March 24, 2026

Re: Santa Maria Community Services
Project No. 25109
Addendum No. 5

1 A111 FIRST FLOOR CEILING PLAN
3/16" = 1'-0"

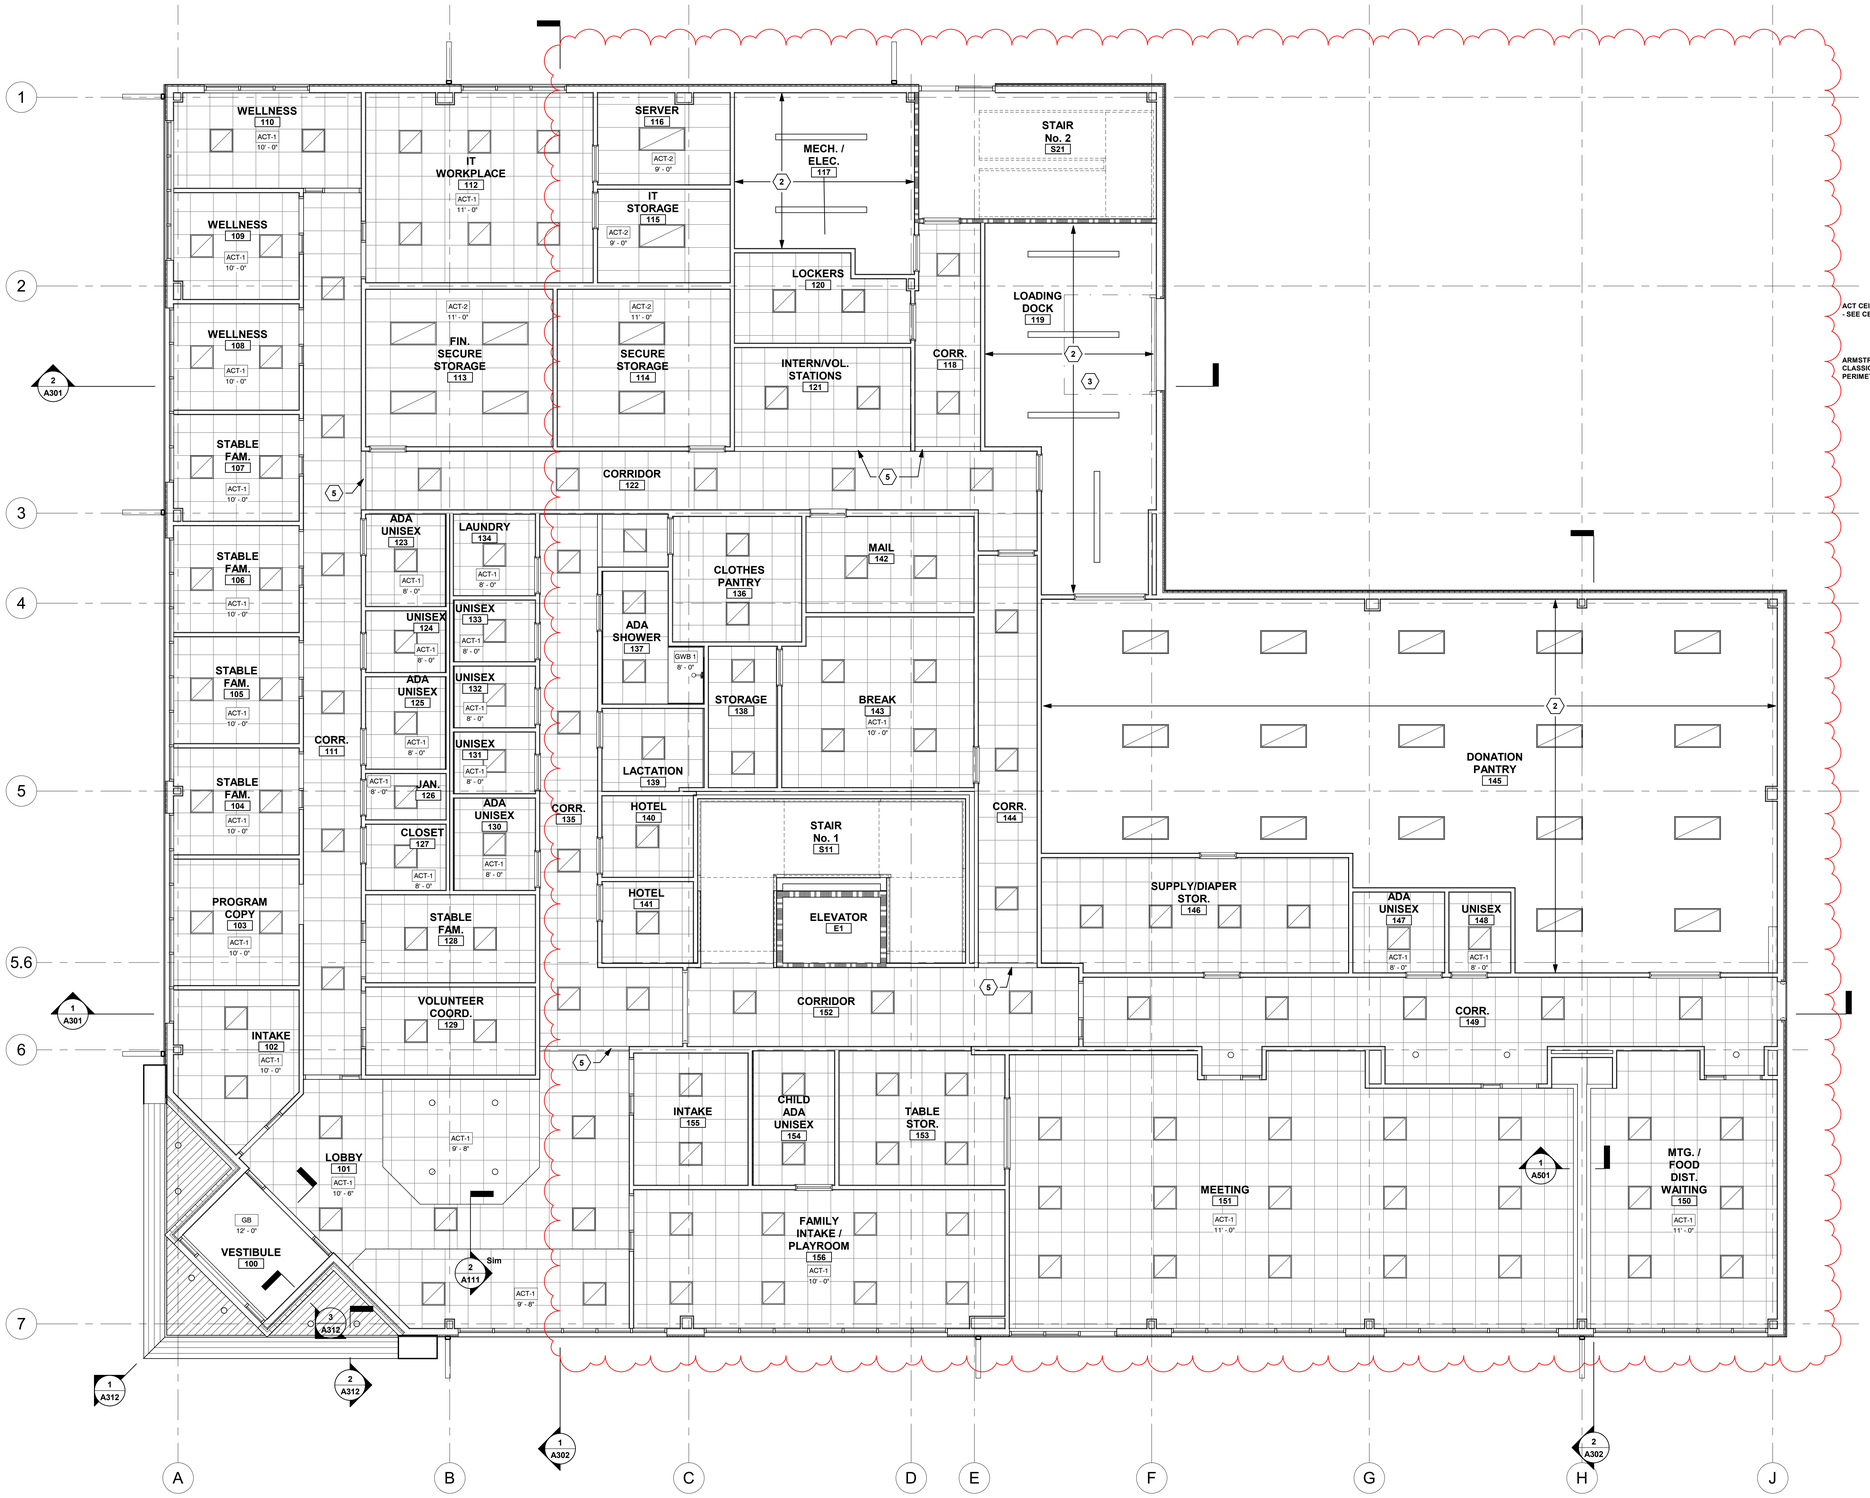
A111 Revisions to the ceilings and lighting layouts of the same spaces.

1 A201 EXTERIOR ELEVATION - WEST
3/16" = 1'-0"

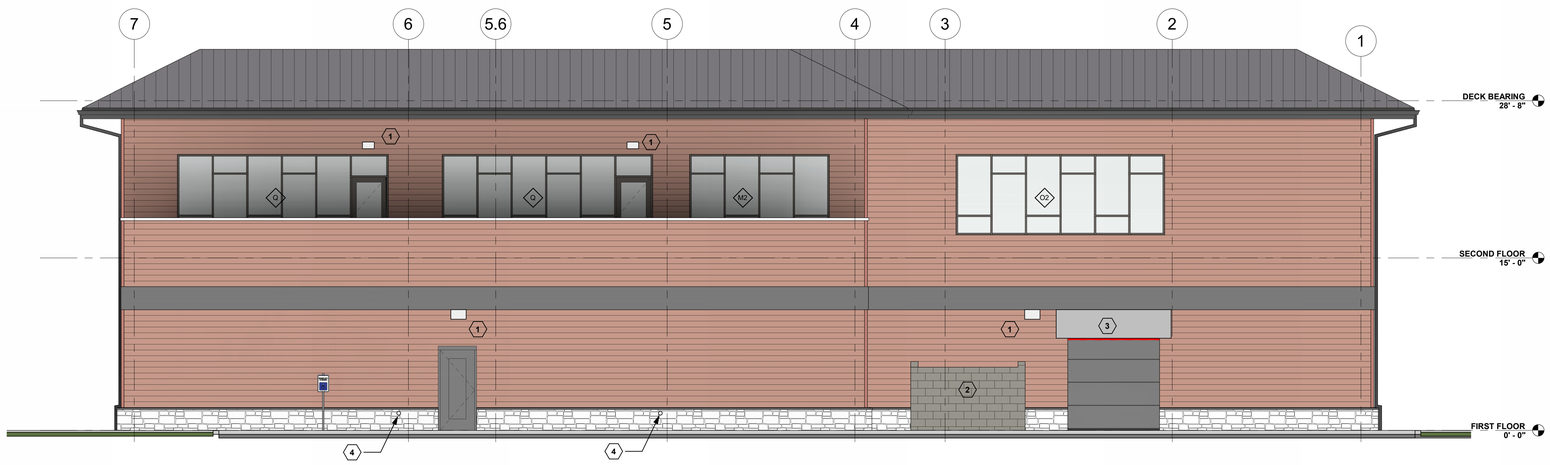
A201 Updated the West Elevation to show the new exit door, detailed into the storefront glazing system.

16 A422 ENLARGED FLOOR PLAN - CHECKOUT COUNTER
1/2" = 1'-0"

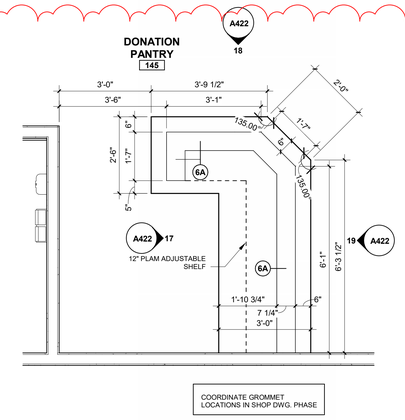
A422 Revisions to enlarged plans and related casework per floor plan changes. Added sales counter plan and elevations.

**P100**

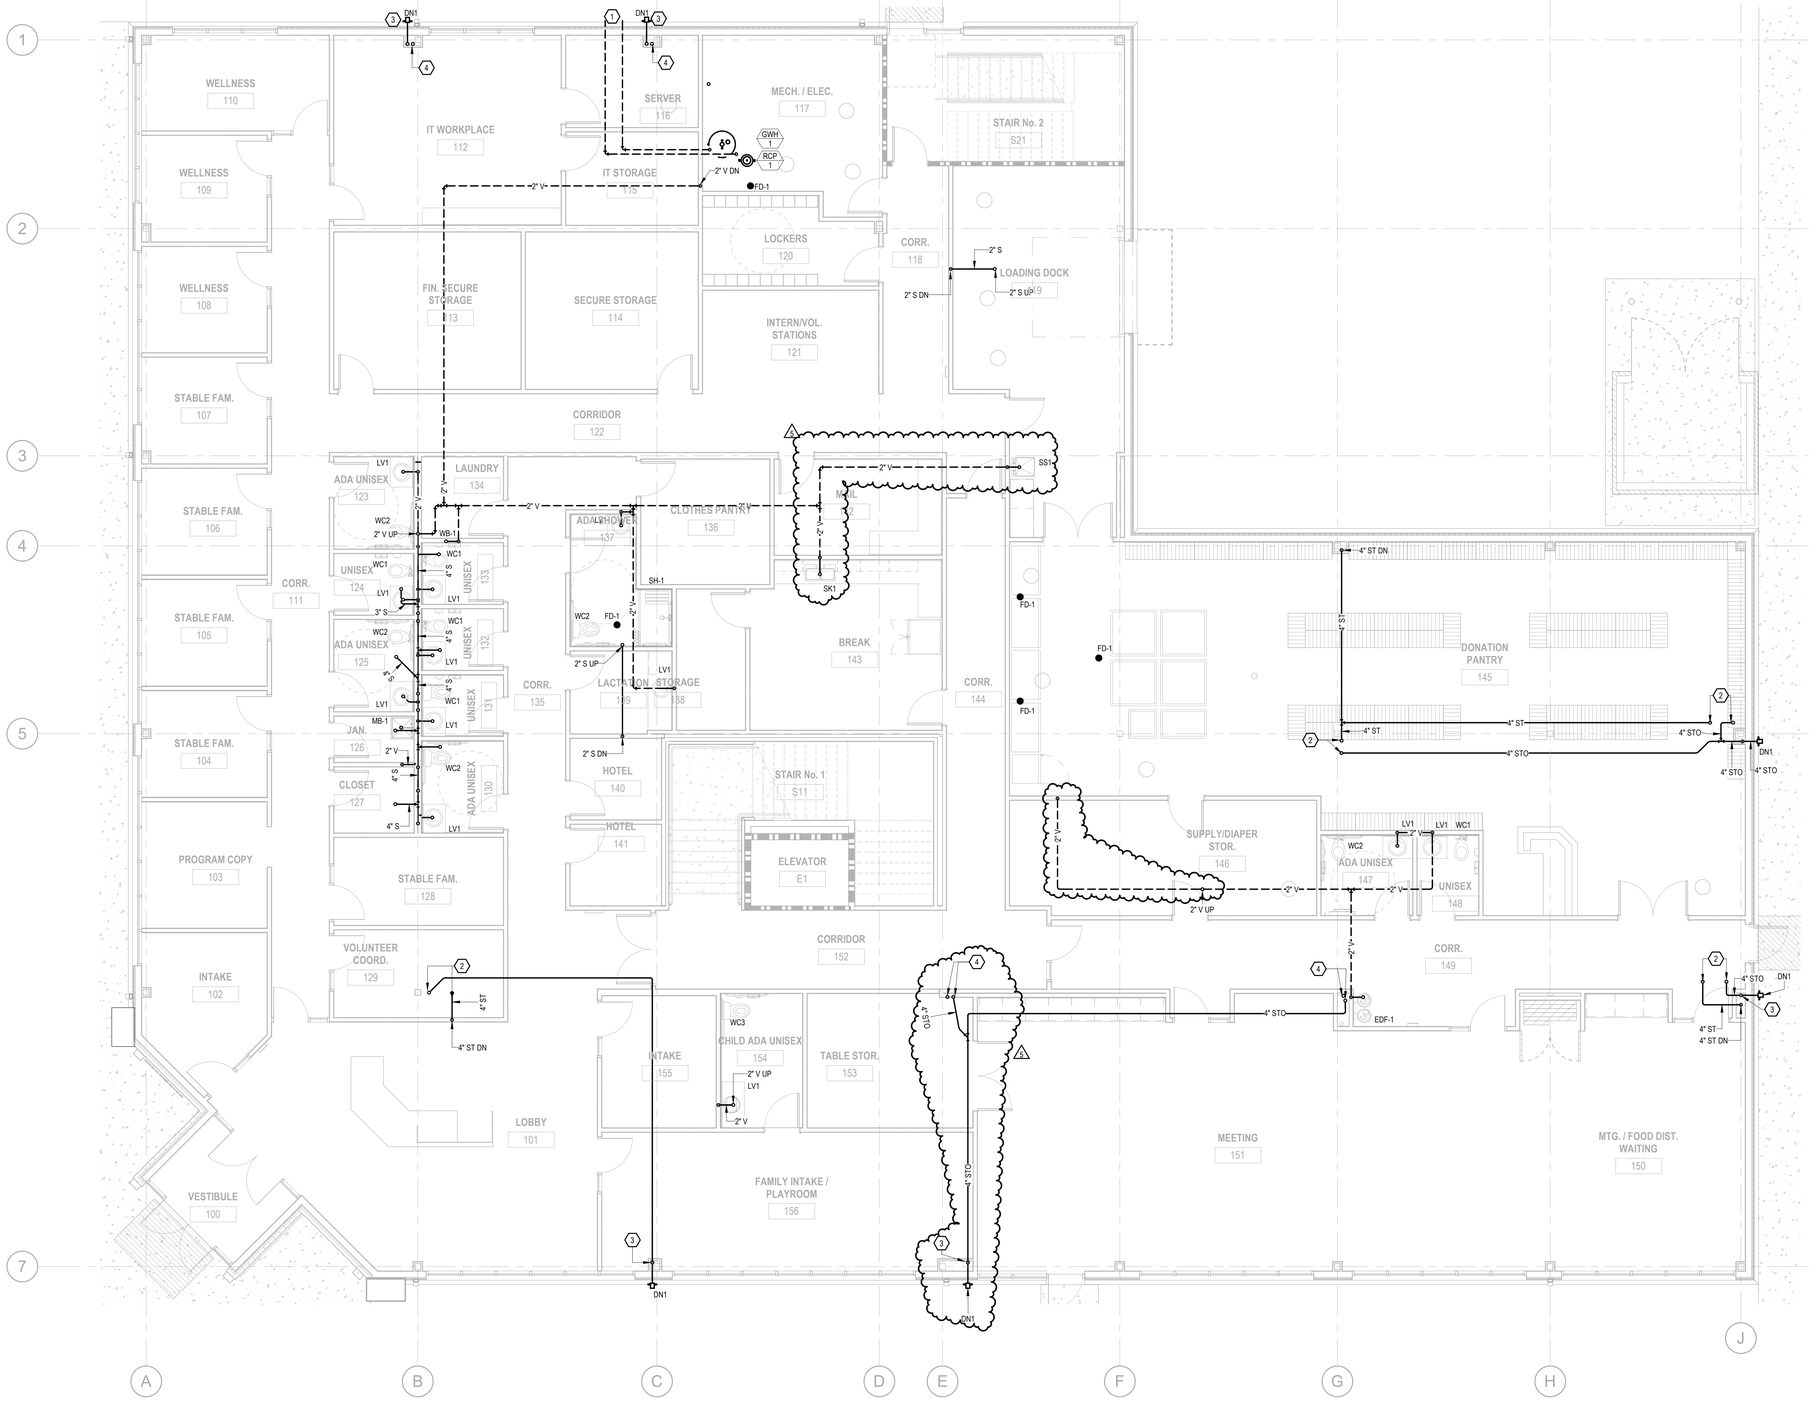
P100 Revised sanitary drop at loading dock to coordinate with wall location.

Adjusted sanitary waste to revised sink location in Break #143.

Service sink and sanitary waste line added in Loading Dock #119.

Added floor drains and adjusted one floor drain in Donation Pantry #145.

1 FIRST FLOOR - DOMESTIC WATER
P201 3/16" = 1'-0"

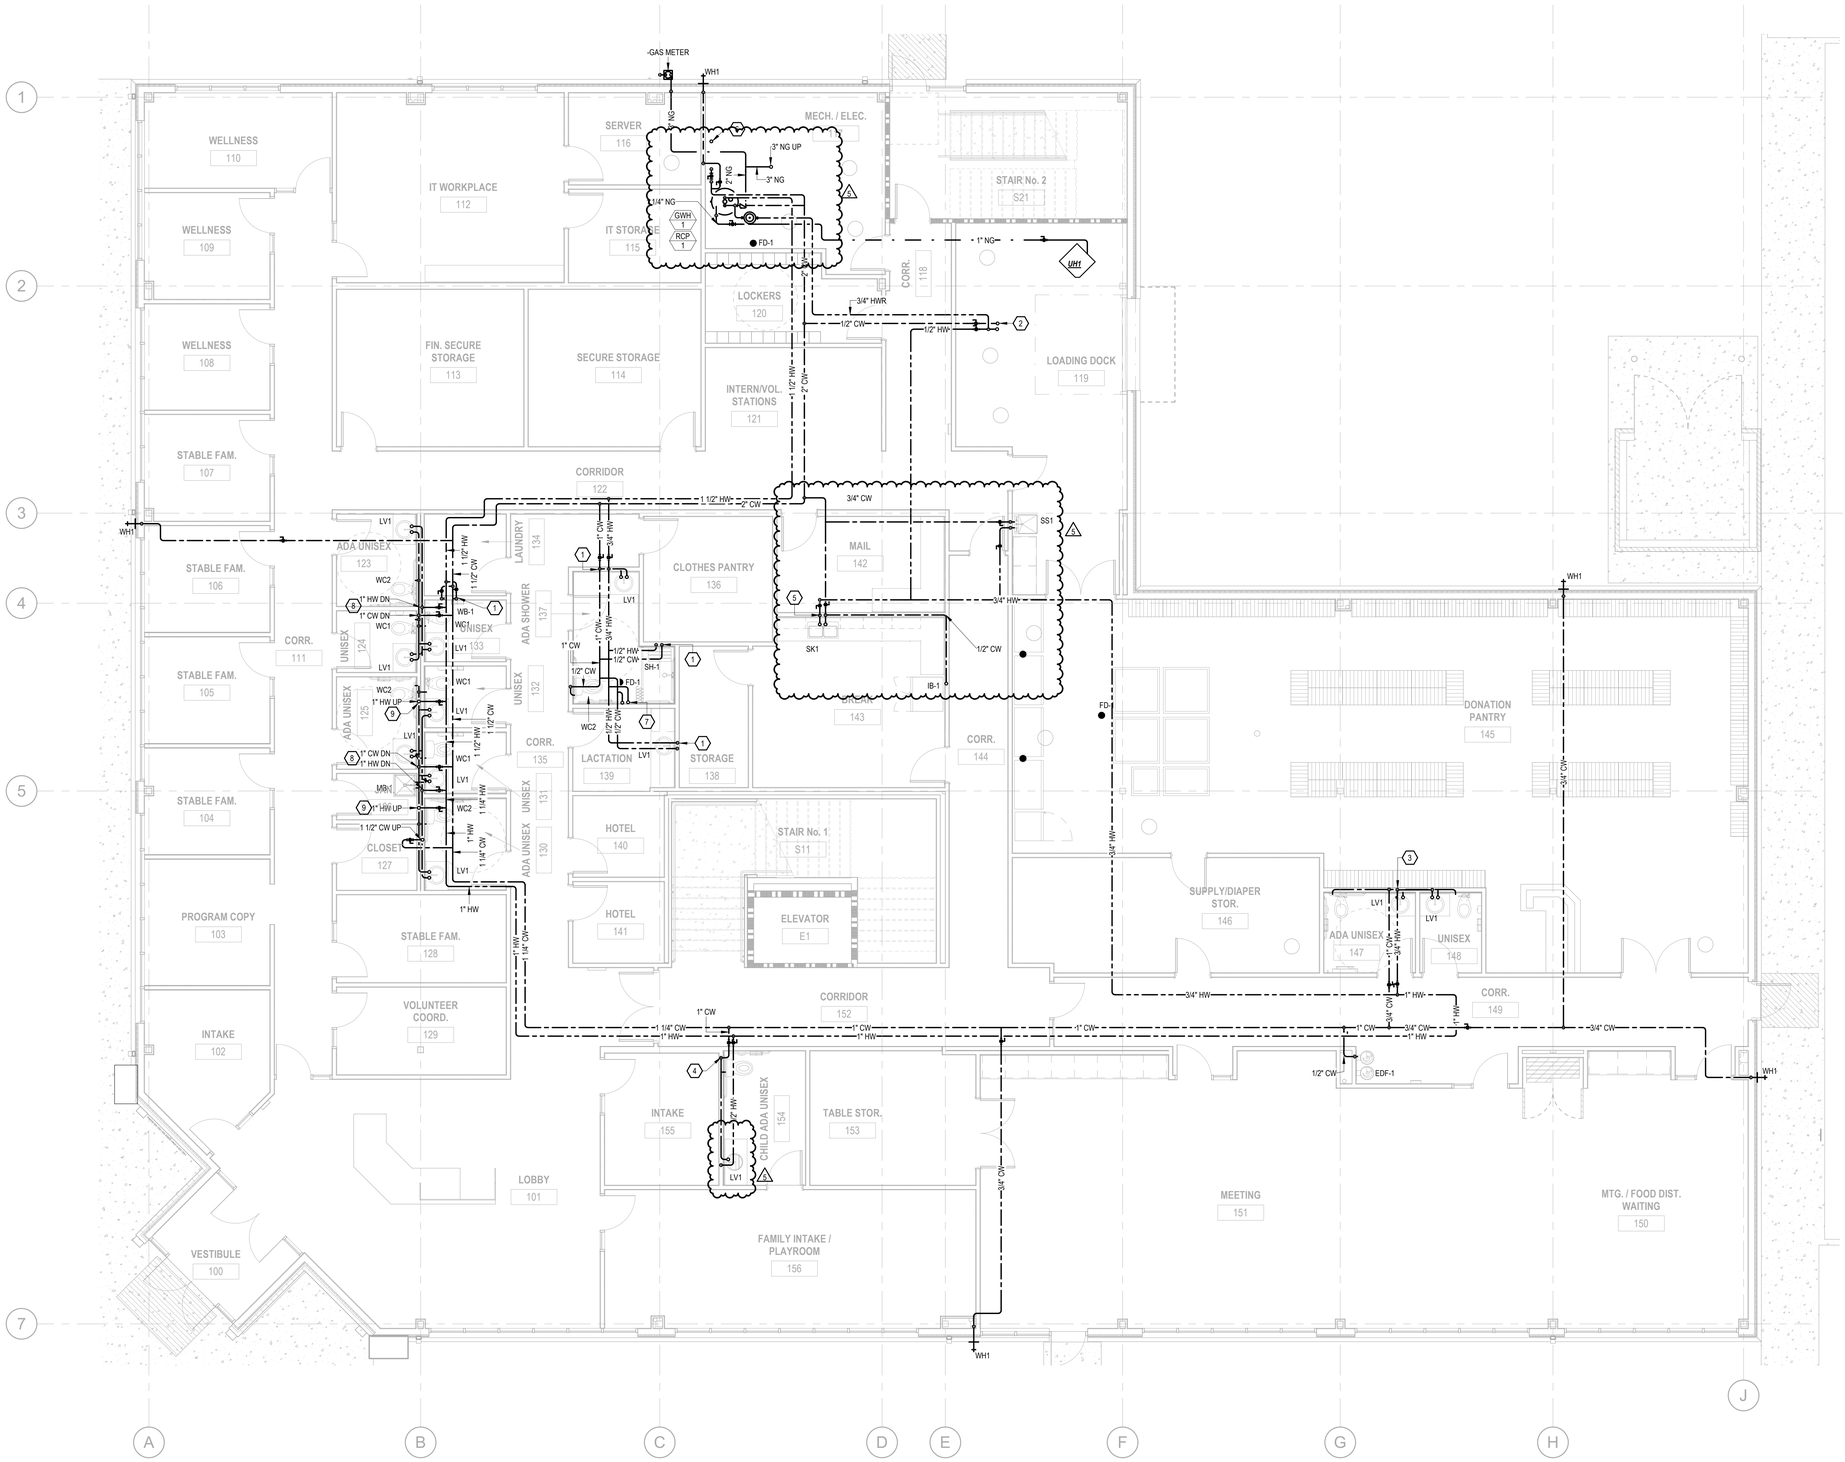
P201 Revised the Mechanical/Elec. #117 piping to coordinate with updated layout.

Added domestic cold and hot water supply to new service sink in Loading Dock #119.

Revised cold and hot supply to revised sink location in Break #143.
